## REGULATORY INFORMATION DISTRIBUTION SYSTEM (RIDS)

SUBJECT: Application for amends to Licenses NPF-41, NPF-51 & NPF-74, D  
 proposing TS Sections 5.3.1 & 5.6.1 & new TS Section  
 3/4.9.13 & Bases 3/4.9.13 re boron concentration-storage S  
 pool.

102-02838-WFC/RAB/GEC  
February 18, 1994

**Subject: Palo Verde Nuclear Generating Station (PVNGS)**  
**Units 1, 2, and 3**  
**Docket Nos. STN 50-528/529/530**  
**Proposed Amendment to Technical Specification Sections 5.3.1 and 5.6.1,**  
**and New Technical Specification Section 3/4.9.13 and BASES 3/4.9.13**  
**File: 94-005-419.05**

FUEL STORAGE RACK  
MODULE ASSEMBLY DETAILS  
(Sheet 1 OF 2)  
Figure 9.1-6

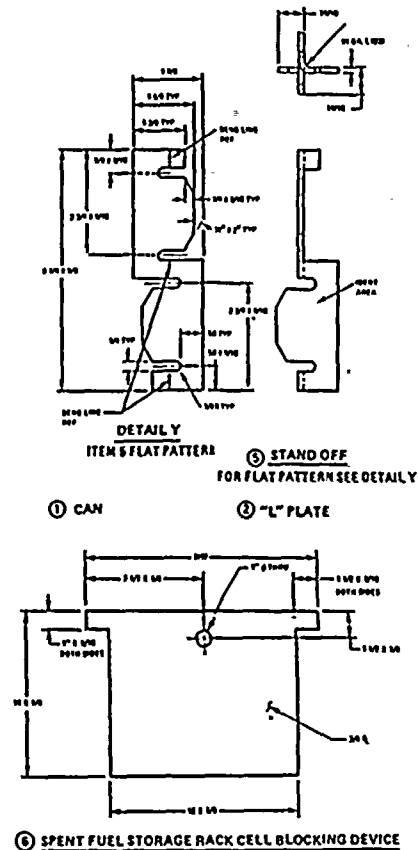
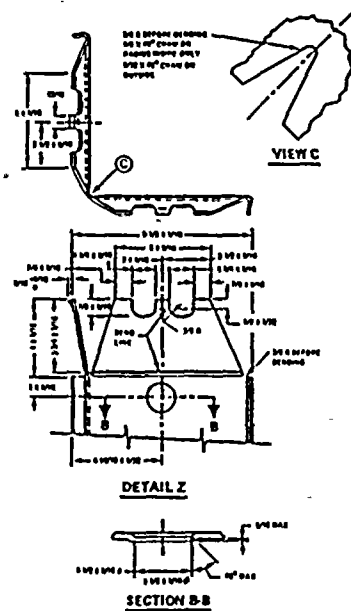
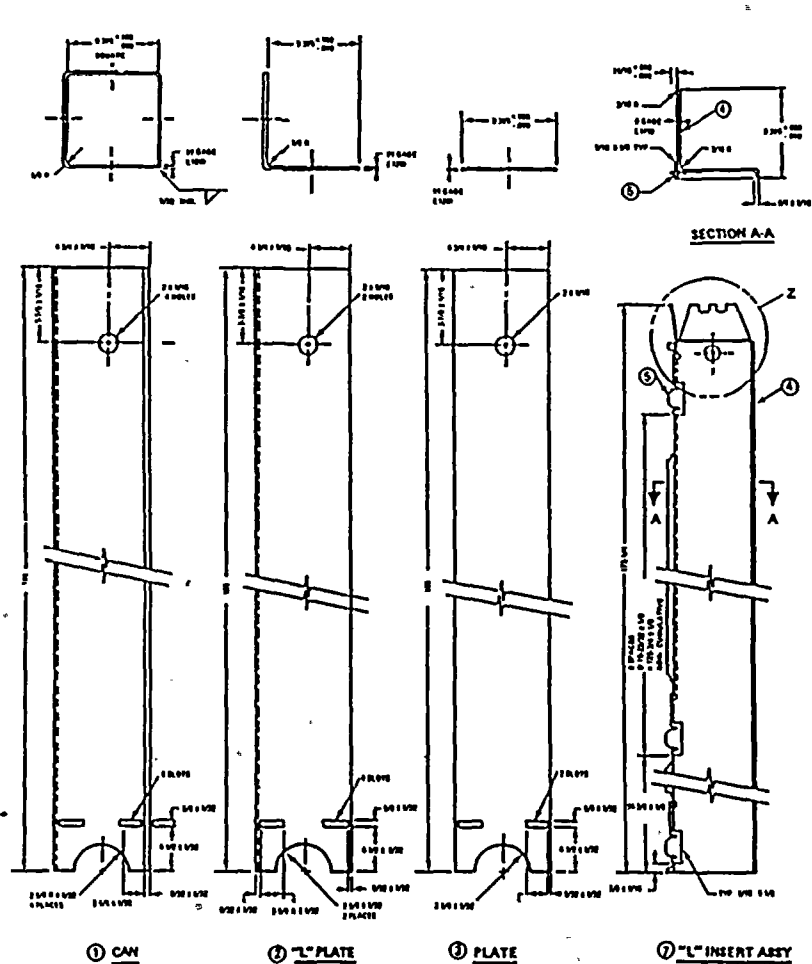
The PVNGS spent fuel storage pool design currently incorporates "L" inserts, as shown in UFSAR Figure 9.1-6 (attached), in two-out-of-four storage rack locations (the "L" inserts are installed in those locations not presently containing cell blocking devices as shown in UFSAR Figure 9.1-5, attached). As part of the plan for increasing available storage in the spent fuel storage pool, APS will not install "L" inserts in the cells where "L" inserts are not presently installed. The safety analysis described in Section D, below, accounts for the "L" inserts presently not installed. In addition, a seismic analysis was performed which concluded that fuel rack stresses, embedment loads, and storage rack mounting pad stresses are

**FIGURE 1**  
**Proposed Spent Fuel Pool Configuration**

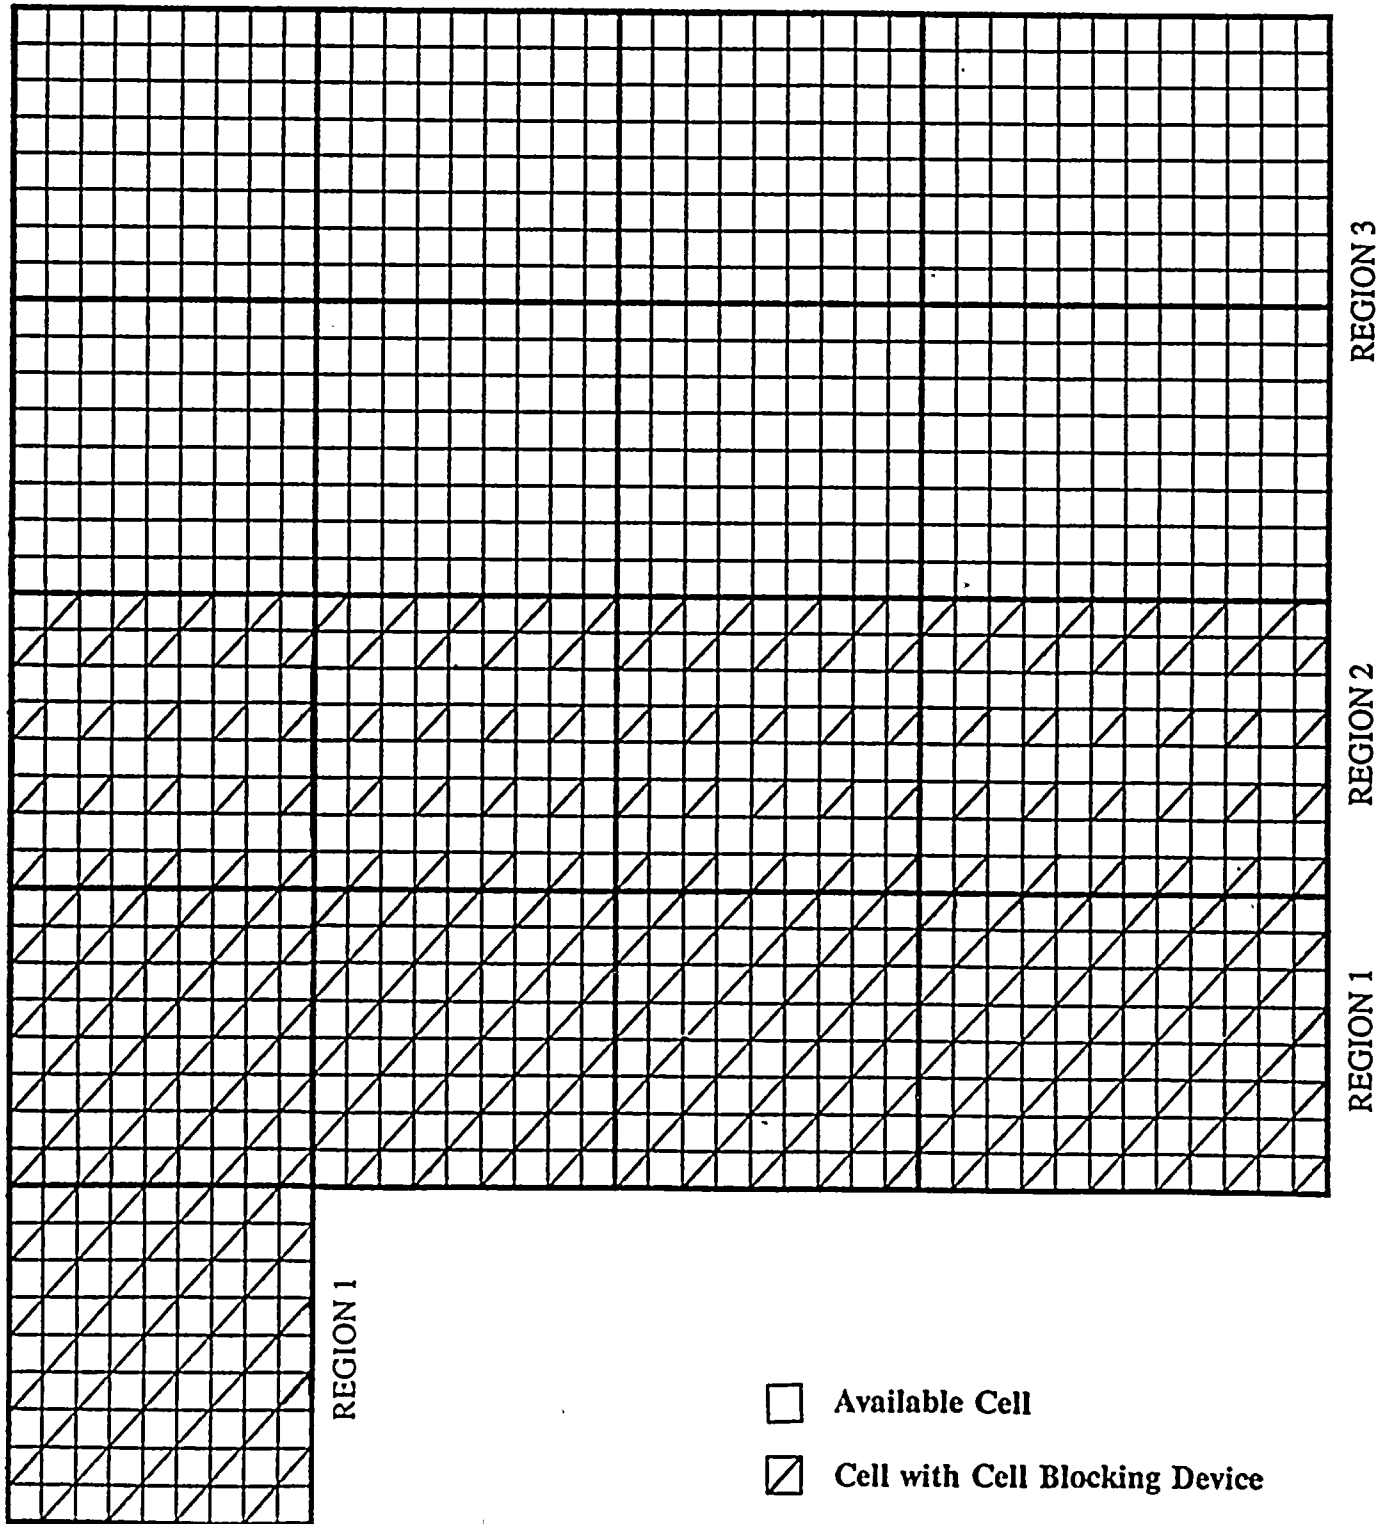
Figure 1 identifies the proposed three region configuration for the PVNGS spent fuel storage pool. Region 1 is comprised of three 9X8 storage racks, one 12X8 storage rack, and one 9X9 storage rack with cell blocking devices already in place in every other storage rack location. Region 2 is comprised of three 9X8 storage racks and one 12X8 storage rack. Cell blocking devices are primarily employed in Region 2 in one out of every four storage rack locations. Additional cell blocking devices are employed in Region 2 along the interface with Region 3, in every other storage rack location, to eliminate the possibility of having an unanalyzed arrangement of assemblies. Figure 1 identifies the required cell blocking device configuration for Region 2. Region 3 is comprised of six 9X8 storage racks and two 12X8 storage racks, and employs no cell blocking devices.

Figure 1 illustrates the proposed three region configuration for the PVNGS spent fuel storage pools. The racks in Region 1 of the pools will be used to store spent fuel assemblies in a two-out-of-four storage configuration. A cell blocking device (shown in USFAR Figure 9.1-6, Sheet 1 of 2, attached) will be used in two of every four storage cell locations. The racks in Region 2 of the pools will be used to store spent fuel assemblies in a three-out-of-four storage configuration. A cell blocking device (shown in USFAR Figure 9.1-6, Sheet 1 of 2, attached) will be used in one of every four storage cell locations (with additional cell blocking devices along the interface with Region 3 to eliminate the possibility of having an unanalyzed arrangement of assemblies). Region 3 will be used to store spent fuel assemblies in a four-out-of-four storage pattern. No cell blocking devices will be employed in Region 3. The current Region 1 pattern of stainless steel "L" inserts, presently installed as shown in UFSAR Figure 9.5-1 (attached) with a nominal thickness equal to 0.175 inches, will also be employed for both Regions 2 and 3.
